SERVICE BULLETIN No. 007LG-32-2

LANDING GEAR - EXTENSION AND RETRACTION - CONTROL AND INTERFACE

LANDING GEAR CONTROL AND INTERFACE UNIT - AMENDMENT A

INTRODUCTION OF ALTERNATIVE PROTECTION BOARD

Figure 1 – View of Rear Module Showing Location of Identification Label

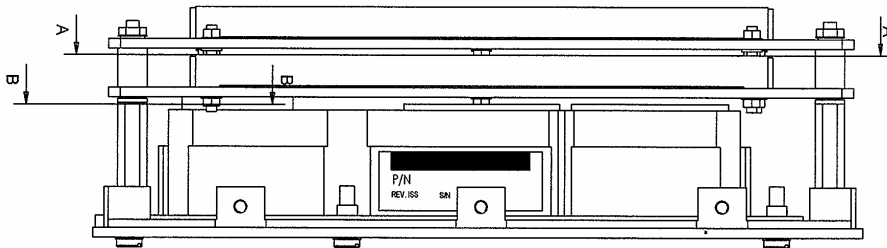
D. Rear Module Re-identification

- (1) Locate Rear Module identification label (Refer to Figure 1).
- (2) Note the Rear Module Serial Number.
- (3) Create new identification label with the following information:

PN: 007-LG-03-0110

Serial No: As noted in paragraph 3. D. (2) suffixed with "Amdt A"

Revision No: 2
- (4) Remove original identification label.
- (5) Fit new identification label.
